Agenda
Hailey Planning and Zoning Commission
Monday, May 19, 2025
5:45 p.m.

FINDINGS OF FACT, CONCLUSIONS OF LAW AND DECISION

On May 5, 2025, the Planning and Zoning Commission considered and recommended for approval a City-initiated infrastructure project pursuant to Title 18: Mobility Design, consisting of the proposed design plans for construction of the Bullion Street Pathway, to be located on the north side of Bullion Street between Main Street and the Hop Porter Stage access road. The recommendation for approval included an amendment to the proposed "Downtown Section 01", to include parallel parking instead of the proposed angled parking, and to widen the sidewalk.

DOWNTOWN MASTER PLAN
PHASE 1 IMPLEMENTATION

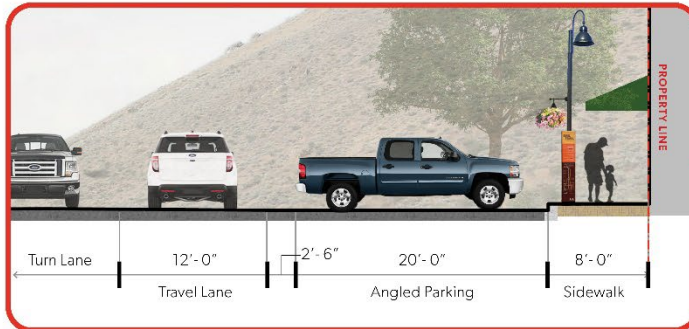
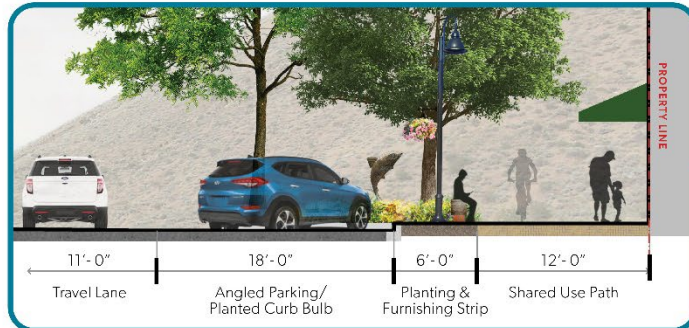
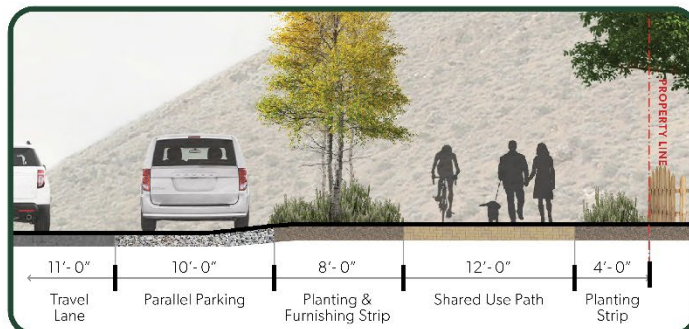
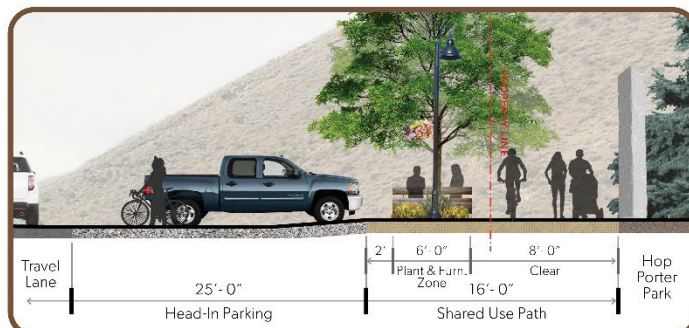
Commission Discussion: The Commission was highly supportive of most aspects of the Bullion Street Pathway Design. Specific elements that garnered positive comments included the tree selections (species and quantity), the inclusion of electric utilities at tree wells to facilitate holiday lighting, and the overall community connectivity that the Pathway is anticipated to bring. Health, safety, economic, and community character benefits were all highlighted as potential project outcomes.

However, four (4) of the five (5) Commissioners expressed acute concern with a small but significant portion of the proposed Pathway design. “Downtown Section 01”, as depicted in [the presentation materials \(see here\)](#) provided by consultant GGLO to City Staff, is located at the corner of W Bullion and Main Street/SH75, on the north side of W Bullion. This section represents the eastern start/end point of the overall Bullion Street Pathway Design proposal.

Regarding the proposed loss of three (3) parking spaces, business owners and some members of the public expressed strong pushback during engagement sessions. One (1) member of the Planning and Zoning Commission attended a recent public workshop and site visit, and they shared their observations from the visit at the May 5, 2025, Public Hearing. Strong business owner sentiment for preserving all existing parking spots with any future development of the Bullion Pathway was expressed, according to the Commissioner who attended. At the May 5, 2025, Public Hearing, all members of the Commission engaged in robust discussion around the need for improved user safety at the corner location, as well as supporting local businesses and a vibrant downtown economy, which accessible, convenient parking helps to facilitate. Present realities and constraints, public feedback, and desired future conditions were all elements to the Commission’s conversation, demonstrating balance and thoughtful consideration amongst the recommending body.

Extensive public comment has been solicited in the form of public meetings and specific work sessions for adjacent residential and commercial businesses. On some topics, such as parking, a variety of viewpoints exist. A compromise design for the first half-block between Main Street and the alley retains the current existing five (5) angle-in parking spaces.

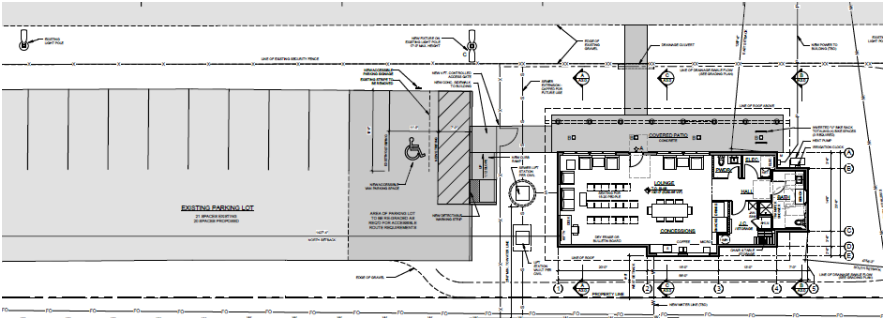
Staff Comments	<p><i>The Applicant is proposing one (1) Dark Bronze wall mounted Architectural wall sconce for the exterior entrance of the building. The wall fixture is 9.2" high and 11.5" wide and has a built-in motion sensor with external dusk to dawn switching. The wall mounted fixture is <u>1,197 Lumens</u>. The Applicant is also proposing four (4) 6" recessed soffit downlighting for the covered patio area which equals <u>(500 each)</u> for a total of <u>2,000 Lumens</u>. One (1) LED Area Luminaire ground fixture is also proposed in Dark Bronze to be placed on an existing light fixture pole that faces east to light the taxi runway and is approximately 17' in height. The ground mounted fixture is <u>5,359 Lumens</u>, for a total of 8,556 Lumens proposed for exterior lighting. An Electrical Photometric Plan has been submitted for your review. Said plan depicts an average foot candle of 1.3, or 0.2 fc less than the maximum average allowed</i></p>

<p>by code. Per Hailey's Municipal Code, the proposed mounting height and output standards have been met. Findings: Compliance. This standard is either not applicable or has been met.</p>																																
			<p>EXTERIOR LIGHTING LEGEND</p> <p>TYPE 'A' ARCHITECTURAL WALL SCONCE 1,197 LUMENS, 10W LED, 2700K 80 CRI MANUF: LITHONIA LIGHTING MAKE: WEDGE LED PACKAGE: P1SW DISTRIBUTION: VW (VISUAL COMFORT WIDE) HEIGHT: 28'-2"; ALIGN W/ SIDING PANEL</p> <p>TYPE 'B' 6" RECESSED SOFFIT DOWNLIGHT 500 LUMENS, 5.1W LED, 2700K 80 CRI MANUF: GOTHAM MAKE: IVO 6" SQUARE DOWNLIGHT BEAM ANGLE: 75° DIMMING LEVEL: MIN. 10% DIM LEVEL HOUSING: NON-IC NEW CONSTRUCTION TRIM: OPEN REFLECTOR FINISH: CLEAR METALIZED - SEMI SPECULAR FLANGE STYLE: SELF FLANGED HEIGHT: PER DRAWINGS</p> <p>TYPE 'C' LED AREA LUMINAIRE 5,359 LUMENS, 45W LED, 2700K 80 CRI MANUF: LITHONIA LIGHTING MAKE: D-SERIES SIZE 0 LED: P2 (20 LED COUNT) DISTRIBUTION: TPTM (FORWARD THROW MED.) MOUNTING: SPA (SQUARE POLE MOUNTING) FINISH: DDBXD (DARK BRONZE) MOUNTING HEIGHT: PER DRAWINGS</p> <p>*SECURITY / EGRESS LIGHT "A" SHALL BE SENSOR ACTIVATED AND TO GO OFF WITHIN FIVE MINUTES AFTER ACTIVATION HAS CEASED</p> <p>ALL EXTERIOR LIGHTING SHALL BE FULL CUTOFF LUMINAIRES WITH THE LIGHT SOURCE DOWNCAST AND FULLY SHIELDED</p> <p>TOTAL LUMEN CALCULATION:</p> <table> <tr> <td>TYPE 'A': 1,197 LUMENS x 1 FIXTURES =</td> <td>1,197 lm</td> </tr> <tr> <td>TYPE 'B': 500 LUMENS x 4 FIXTURES =</td> <td>2,000 lm</td> </tr> <tr> <td>TYPE 'C': 5,359 LUMENS x 1 FIXTURES =</td> <td>5,359 lm</td> </tr> <tr> <td>TOTAL LUMENS:</td> <td>8,556 lm</td> </tr> </table> <p>MOUNTING HEIGHT/LAMP OUTPUT RECOMMENDATIONS</p> <table> <thead> <tr> <th>Mounting Height (Feet)</th> <th>Max Lumens</th> </tr> </thead> <tbody> <tr><td>6</td><td>1,000</td></tr> <tr><td>8</td><td>1,600</td></tr> <tr><td>10</td><td>2,000</td></tr> <tr><td>12</td><td>2,400</td></tr> <tr><td>16</td><td>6,000</td></tr> <tr><td>20</td><td>8,000</td></tr> <tr><td>24</td><td>9,000</td></tr> <tr><td>28</td><td>12,000</td></tr> <tr><td>32</td><td>24,000</td></tr> <tr><td>36</td><td>28,000</td></tr> <tr><td>40 or more</td><td>32,000</td></tr> </tbody> </table>	TYPE 'A': 1,197 LUMENS x 1 FIXTURES =	1,197 lm	TYPE 'B': 500 LUMENS x 4 FIXTURES =	2,000 lm	TYPE 'C': 5,359 LUMENS x 1 FIXTURES =	5,359 lm	TOTAL LUMENS:	8,556 lm	Mounting Height (Feet)	Max Lumens	6	1,000	8	1,600	10	2,000	12	2,400	16	6,000	20	8,000	24	9,000	28	12,000	32	24,000	36	28,000	40 or more	32,000

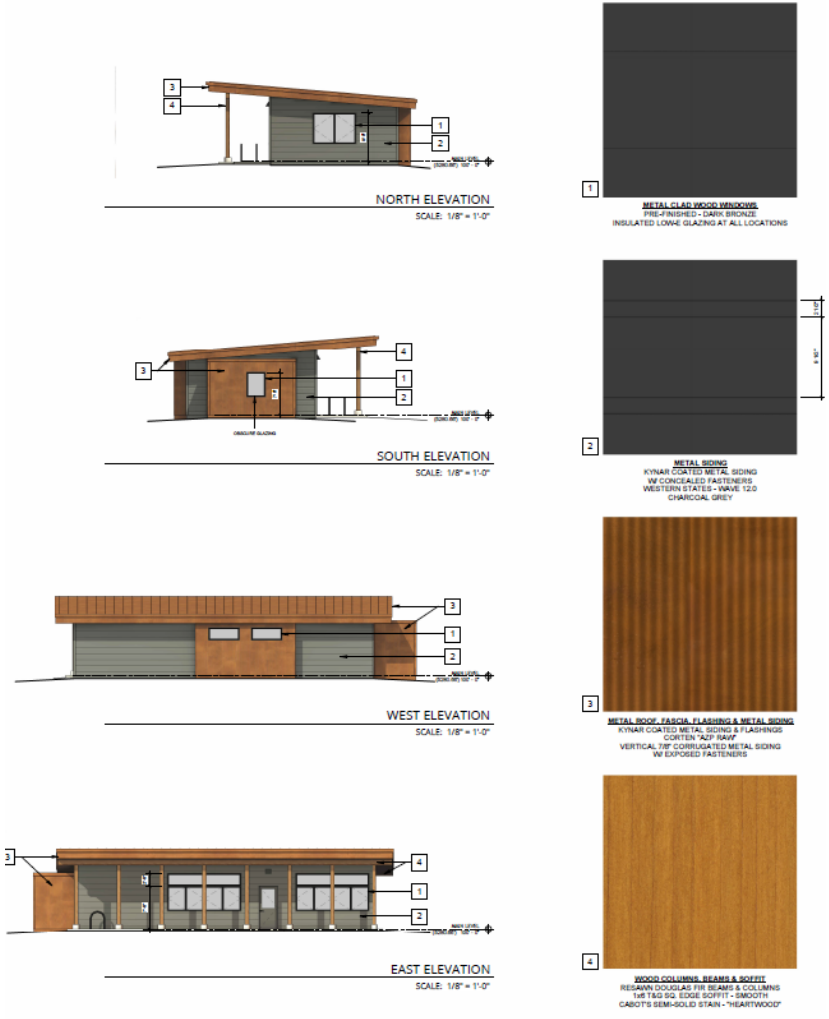
Staff Comments	<p><i>The proposed building is not over two stories in height and proposes a variety of colors, various siding and materials, to provide human scale to the building façades.</i></p> <p><i>Findings: Compliance. This standard is either not applicable or has been met.</i></p>
<input checked="" type="checkbox"/>	<input type="checkbox"/>	<input type="checkbox"/>	17.06.080(A)2i	<p>i. All buildings shall minimize energy consumption by utilizing alternative energy sources and/or passive solar techniques. At least three (3) of the following techniques, or an approved alternative, shall be used to improve energy cost savings and provide a more comfortable and healthy living space:</p> <ul style="list-style-type: none"> i. Solar Orientation. If there is a longer wall plane, it shall be placed on an east-west axis. A building's wall plane shall be oriented within 30 degrees of true south. ii. South facing windows with eave coverage. At least 40% of the building's total glazing surface shall be oriented to the south, with roof overhang or awning coverage at the south. iii. Double glazed windows. iv. Windows with Low Emissivity glazing.

16.04.020: Streets:				
Compliant			Standards and Staff Comments	
Yes	No	N/A	City Code	City Standards and <i>Staff Comments</i>

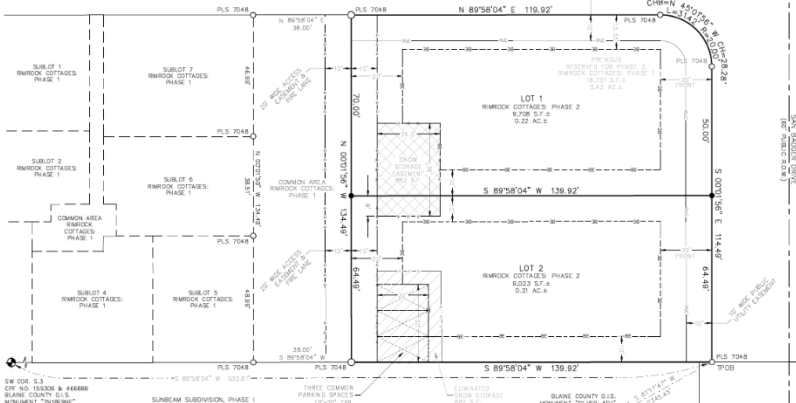
Staff Comments	<p>The locations of the proposed buildings were planned in an earlier phase of this development, with the integration of the existing public streets (E. Myrtle Street and San Badger Drive), as well as from the existing access lane that separates Phase I and Phase II. Both public streets and access lane have been considered and accounted for in the design and buildout of Phase II.</p> 
<input type="checkbox"/>	<input type="checkbox"/>	<input checked="" type="checkbox"/>	B.	Cul-De-Sacs; Dead-End Streets: Cul-de-sacs or dead-end streets shall be allowed only if connectivity is not possible due to surrounding topography or existing platted development. Where allowed, such cul-de-sacs or dead-end streets shall comply with all regulations set forth in the IFC and other applicable codes and ordinances. Street rights-of-way extended into un-platted areas shall not be considered dead end streets.

Amended plans:

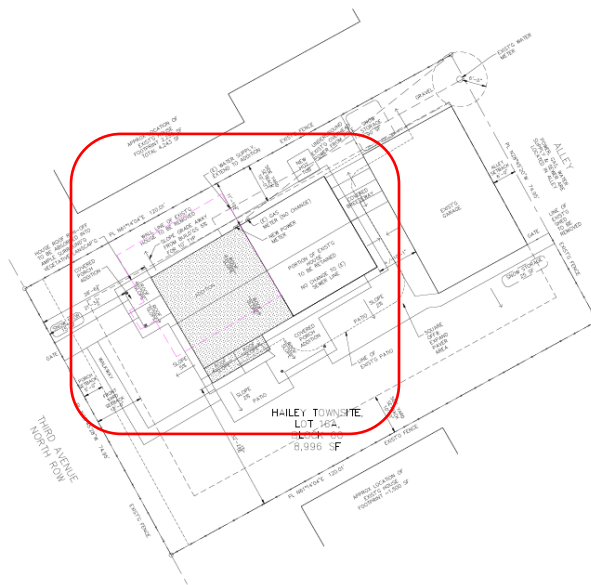
- The single-family addition is reduced by approximately 20% in size, due to 13' of the E/W length of the addition being removed. The originally approved addition of 1,087 square feet has been reduced to 734 square feet. The exterior building materials, house shape, location, height and exterior lighting remain the same as originally approved.

- The originally proposed and approved ADU was eliminated via a Design Review Modification of the garage at time of building permit submittal.
- The exterior color has also been amended. The proposed addition was formerly a light gray paint color for the board and batten siding on the garage. The Owners are proposing to match the dusty blue color on the existing house: The board and batten on the house will be painted to match the approved dark blue of the garage siding, which will match the existing blue siding on the ground floor rear of the house.
